TOWN OF RAYMOND

Planning Board Agenda

Application # 2022-001: A SITE PLAN application is being submitted by John Lorden of Tighe & Bond, Inc. on behalf of Pinard Waste. They are proposing to construct a 30' x 40' metal building, a 1,260-sf office addition, and 10,575 sf proposed addition/overhang for the recycling processing program. Also, to be included with the project, is a small parking area, existing gravel/paved areas to be repaved, site lighting, a truck scale, proposed electrical, and a proposed gravel area for storage. To offset newly paved areas, stormwater treatment practices in the form of infiltration ponds and gravel wetlands are proposed. Property is located at 3 Otter Court and Raymond Tax Map 28-4 / Lot 2.

Subject: Review of Application 2022-001 Site Plan Application – 3 Otter Court Raymond, NH 03077 (Tax Map 28-4 Lot 2)

C-502

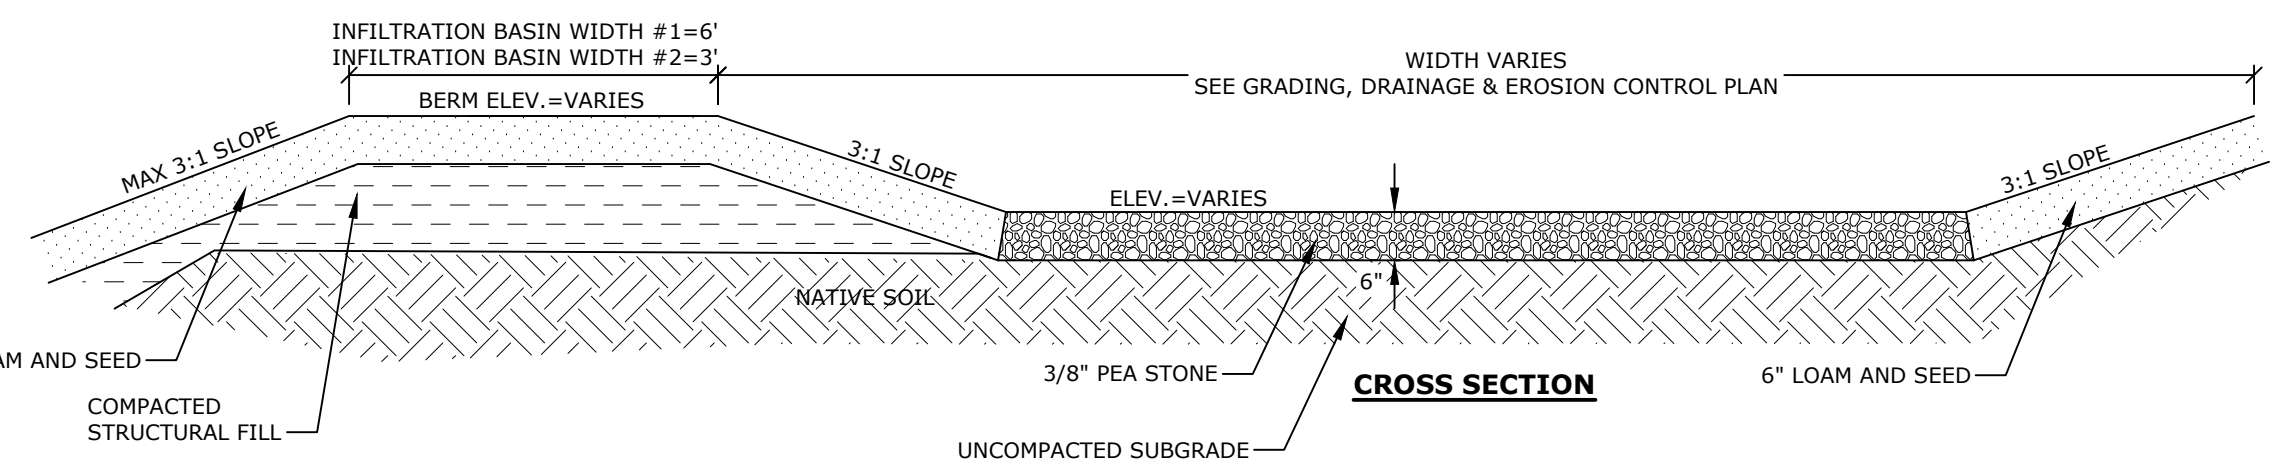
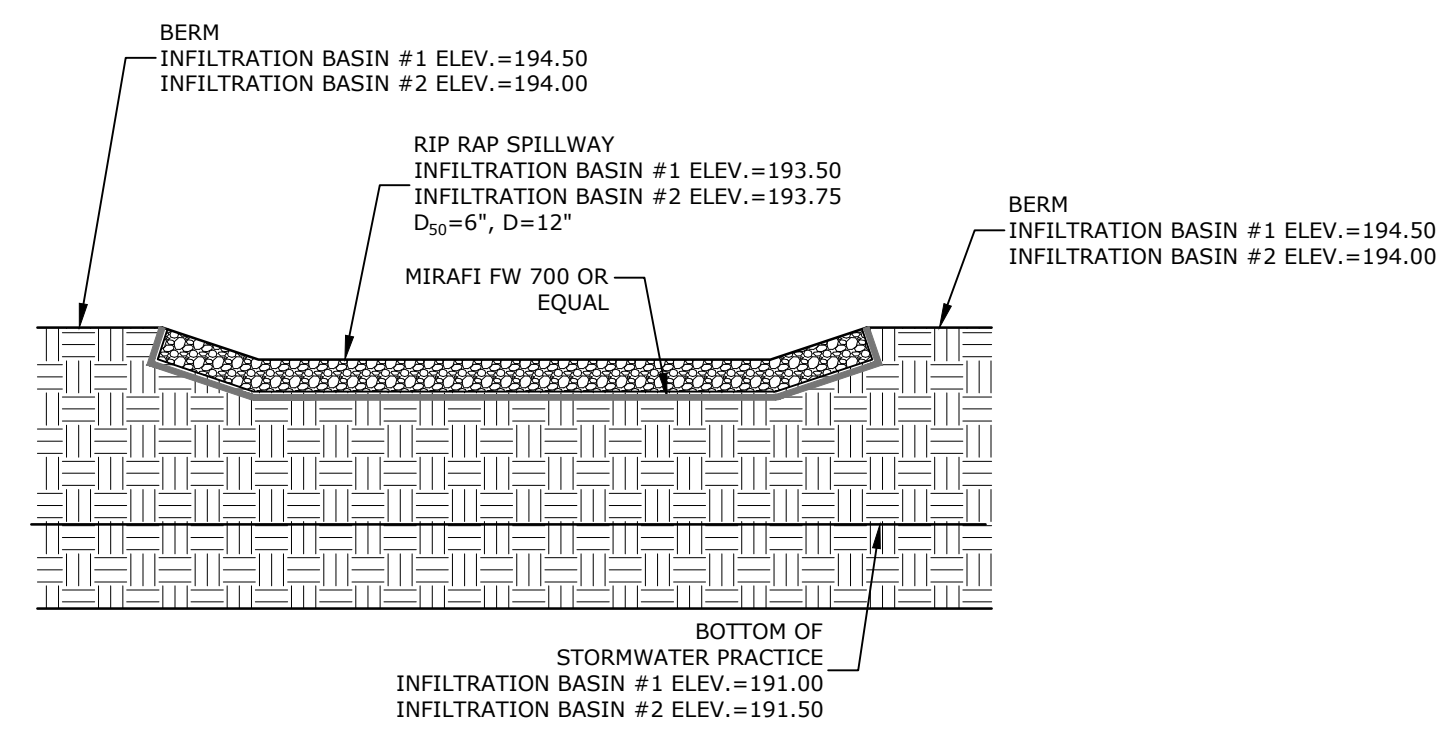
9. Details, Sheet C-502

- a. We recommend that the Applicant revise the sheet and additionally provide rip-rap details for Infiltration Basin 2 and Gravel Wetland Cell #2. We also recommend that the applicant add the dimensions of the proposed rip-rap.
- b. We recommend that the Applicant revise the grass-lined swale detail. The proposed width of bottom of swale is labeled as 2', which is not consistent with the drainage analysis. The required width must be between 4' to 8', in accordance with New Hampshire Stormwater Manual, Volume 2.
- c. We recommend that the Applicant revise the pavement section notes to include the requirements indicated in the Site Plan Regulations sections 6.07.01, 6.07.02, 6.07.04 and 6.07.05.
- d. Infiltration Basin Detail. We recommend that the Applicant expand the detail to show berm construction requirements.
